Work Order ID 98001

Item Name: 205 Bent Tube

DRAWING NO. D2580	TITLE 205 SKIDTUBE ASSEMBLY	REV. E	DART AEROSPACE LTD ENGINEERING ORDER		D.E.O. NO. D2580-E-1	SHEET NO. SHEET 1 OF 1	SCALE NTS
DRAWN <i>UP</i>	CHECKED <i>ASS</i>	MFG. APPR. <i>EC</i>	APPROVED <i>[Signature]</i>		DE APPR. <i>[Signature]</i>		
DATE 11.12.13	DATE 11.12.13	DATE 11.12.13	DATE 11.12.13		DATE 11.12.13

CHANGE ALL C'BORED WELDED CROSSBOLT SPACERS TO SWAGED SPACERS

SECTION B-B, F-F, I-I
NOT TO SCALE

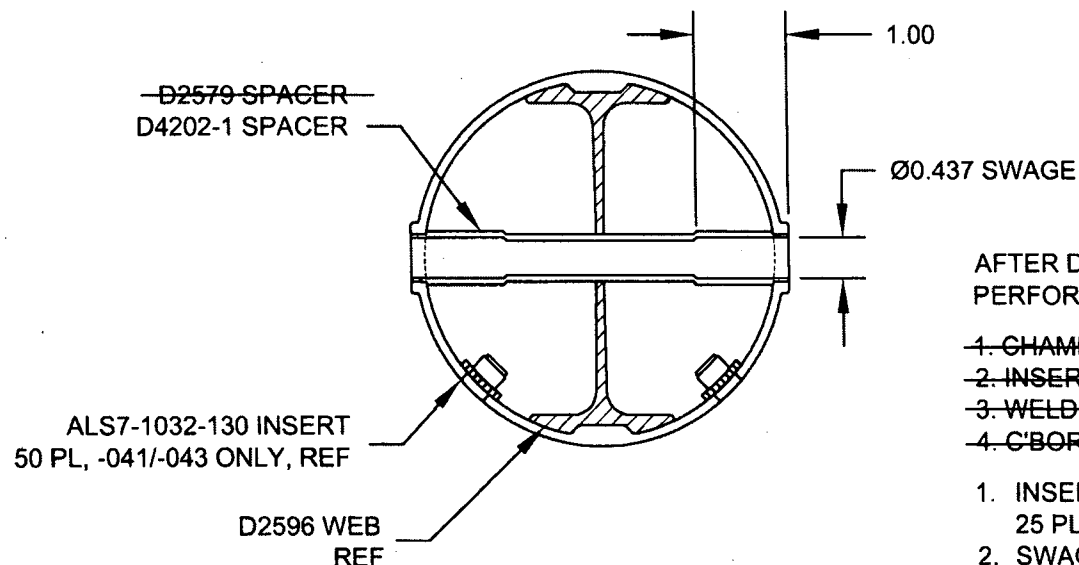
SECTION B-B, SECTION F-F, & SECTION I-I ARE AMENDED AS FOLLOWS
FOR ALL HOLES THAT WERE ORIGINALLY C'BORED:

*** FOR -045 SKIDTUBE ONLY:**

WELD 4X D2579 SPACERS PER DWG
IN LOCATIONS MARKED "NO C'BORE".
REF SHEET 4 OF DWG.

1. CHAMFER HOLE 0.050 X 45°
2. INSERT D2579 SPACER (20 PLACES)
3. WELD INTO PLACE AND GRIND FLUSH
4. C'BORE D2579 SPACER TO Ø0.437 X 1.00 DEEP

1. INSERT D4202-1 SPACER, 20 PL (-041) OR 20 PL (-045) OR 25 PL (-047)
2. SWAGE TO Ø0.437 X 1.00 DEEP PER QSI 002
3. TRIM / GRIND FLUSH PER QSI 002
